**The George Washington University
Square 103 - Phase 1 Design
Garage Base Building**

**REVISED FOGGY BOTTOM CAMPUS PLAN PUD
SECOND STAGE APPROVAL**

MAY 11, 2012

A9.R

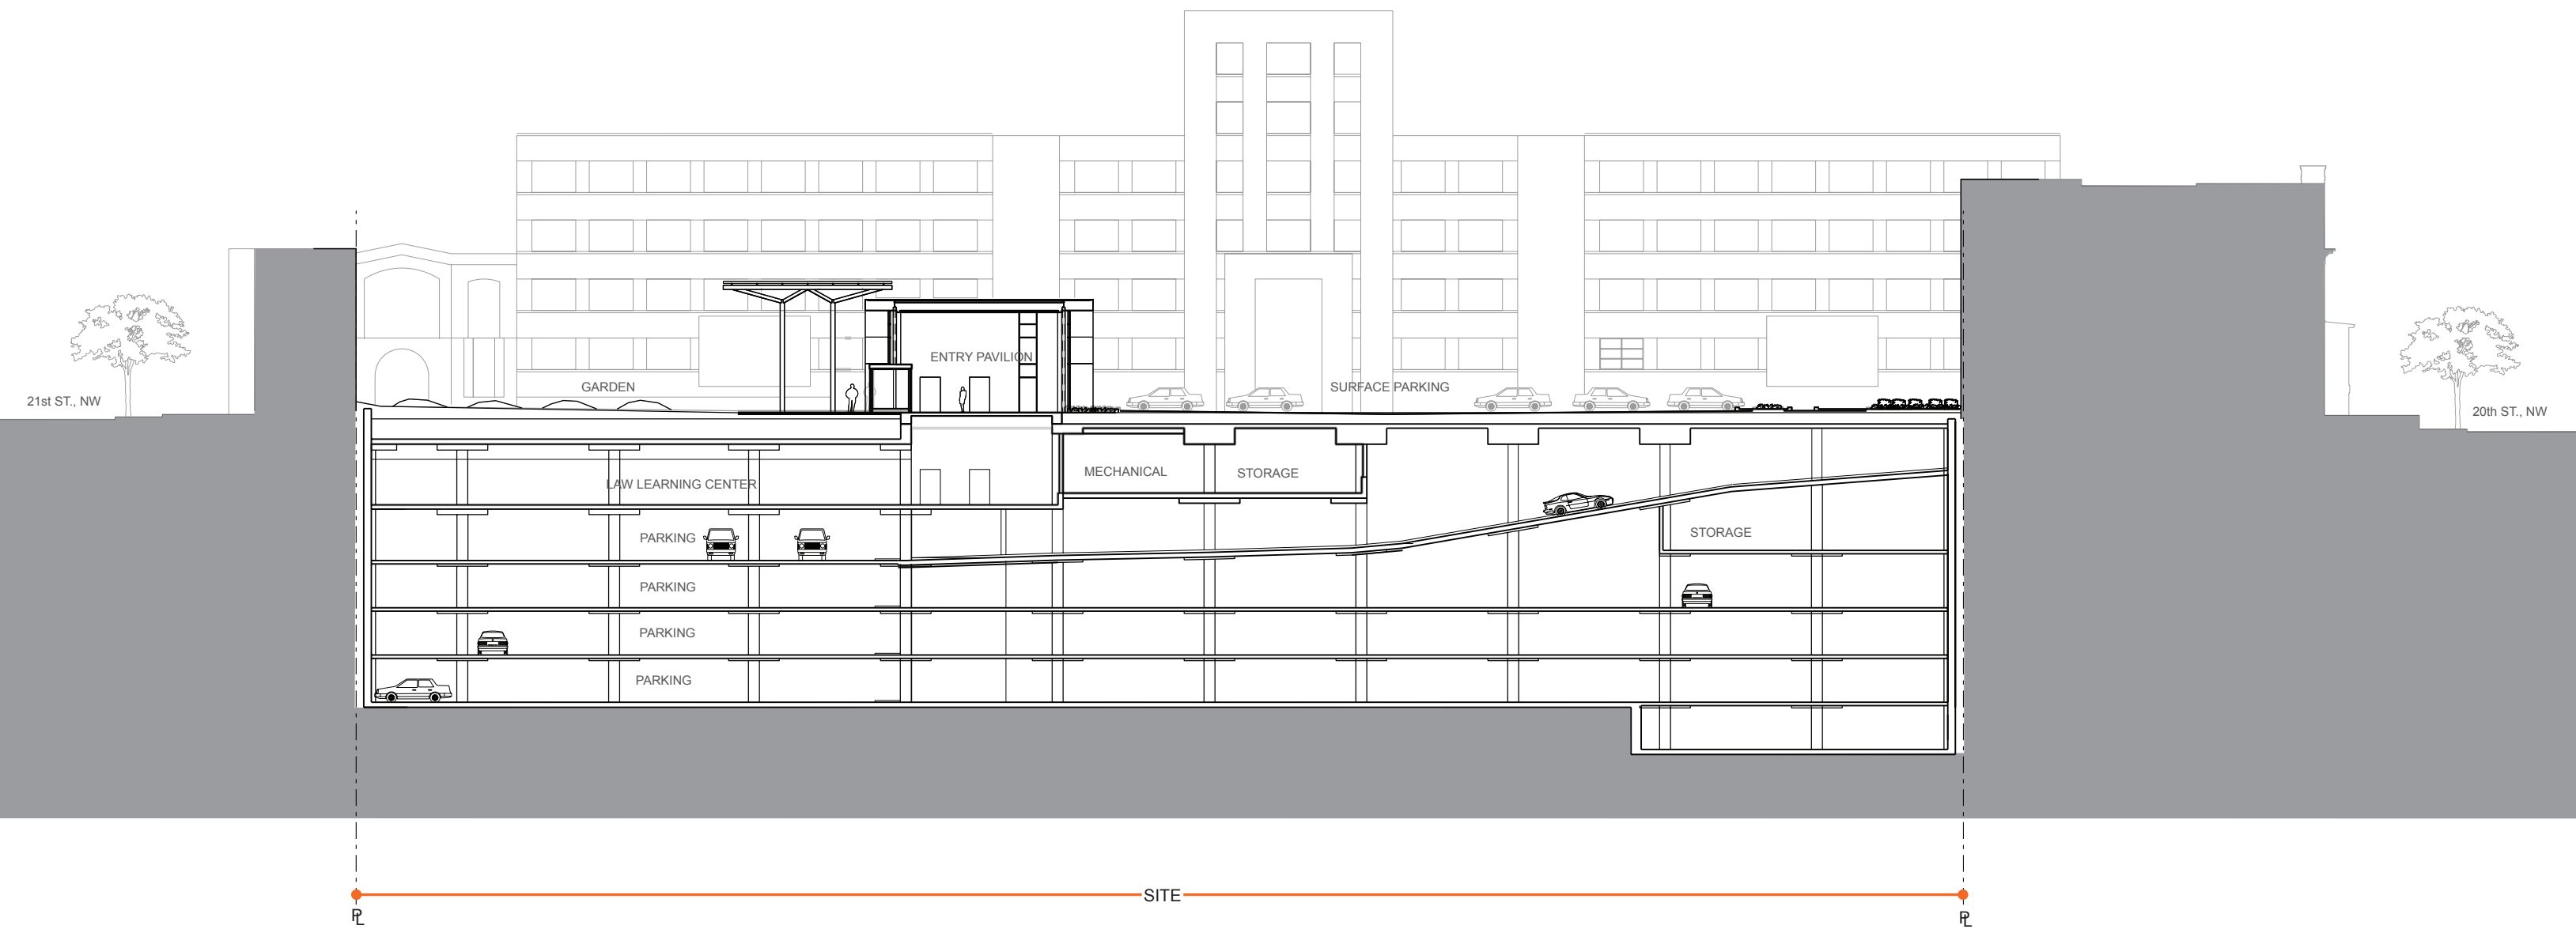
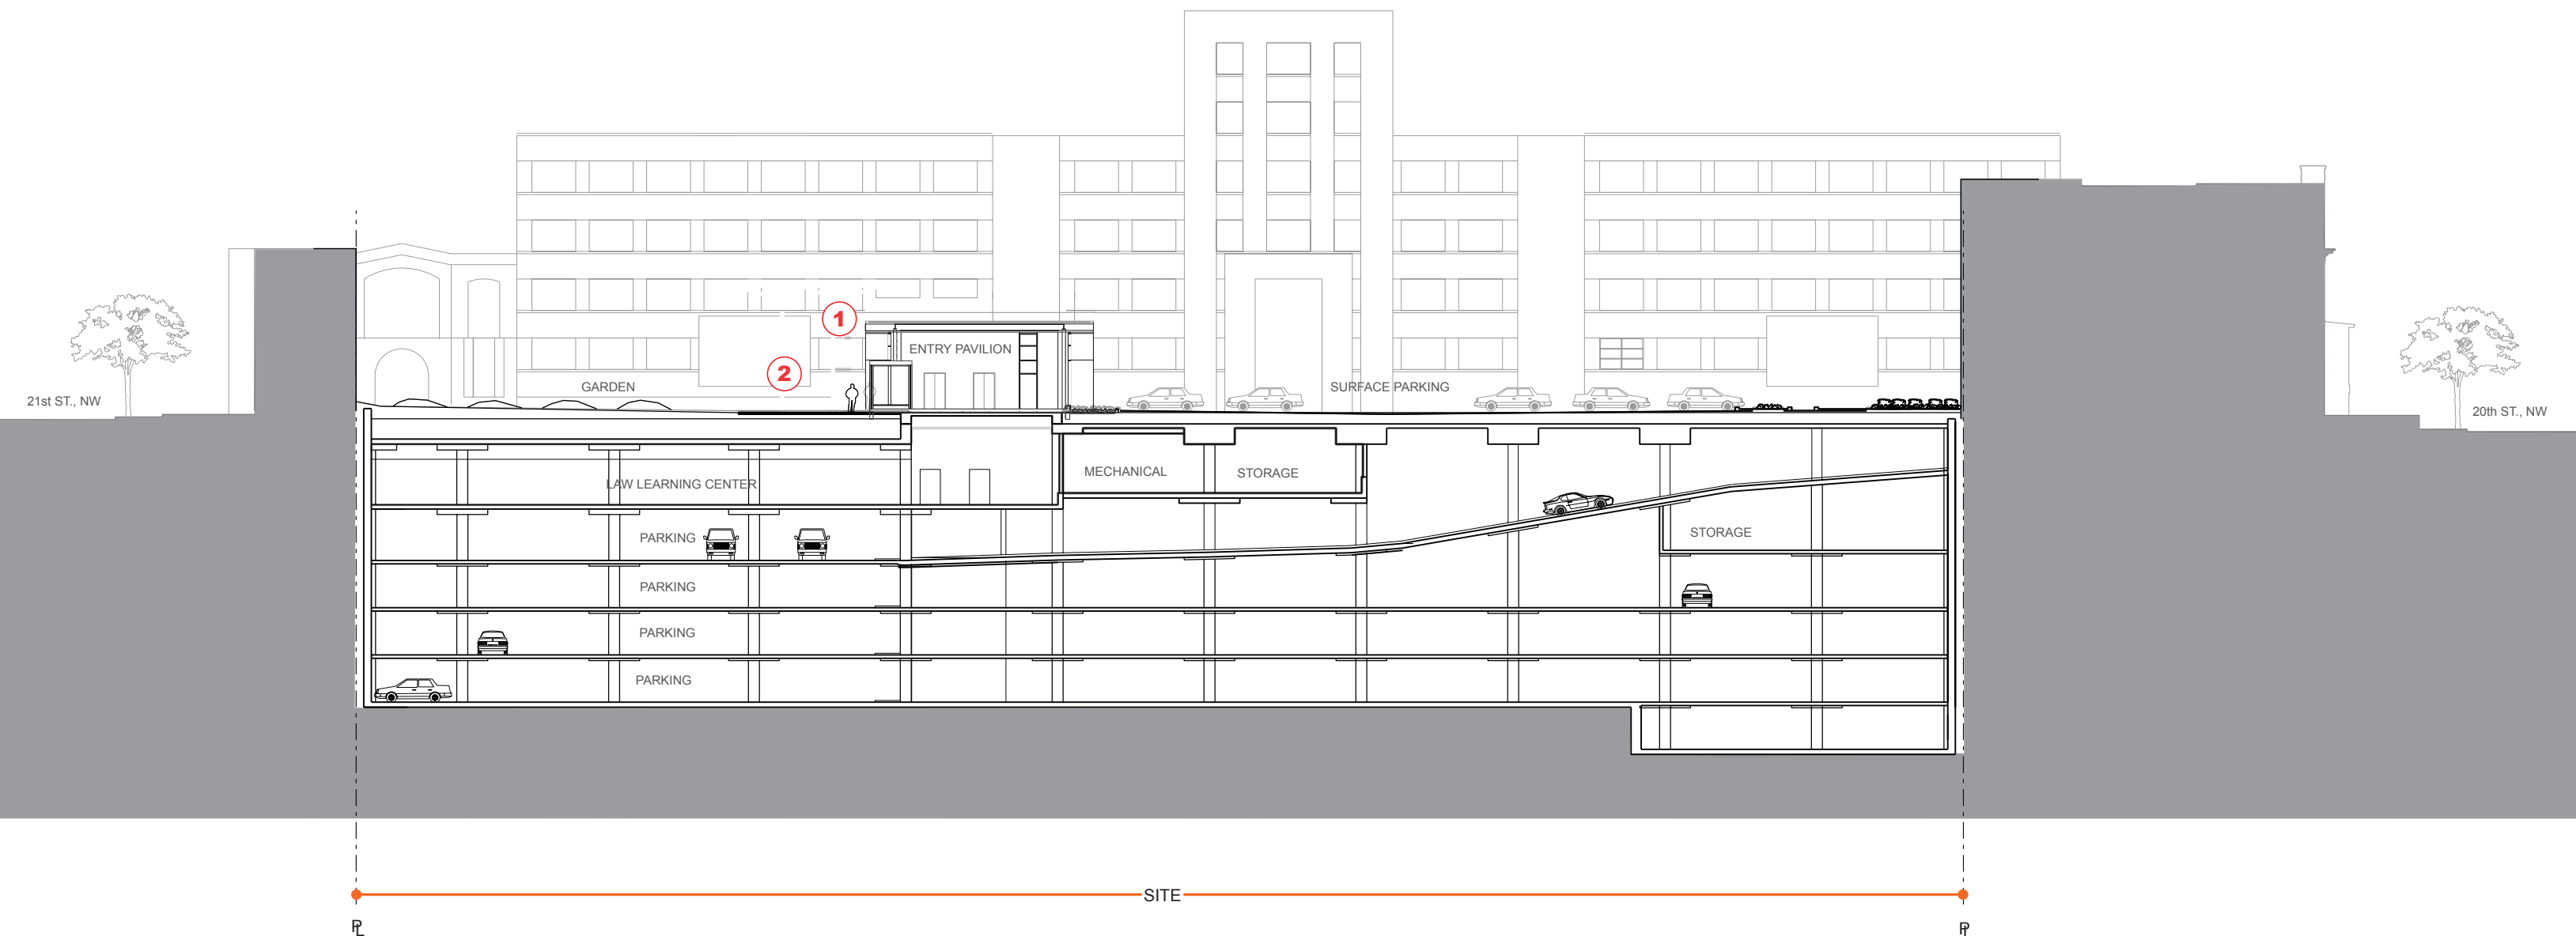
KEYPLAN
 1. Reduce Pavilion height from 23'-0" to 18'-3"
 2. Remove trellis
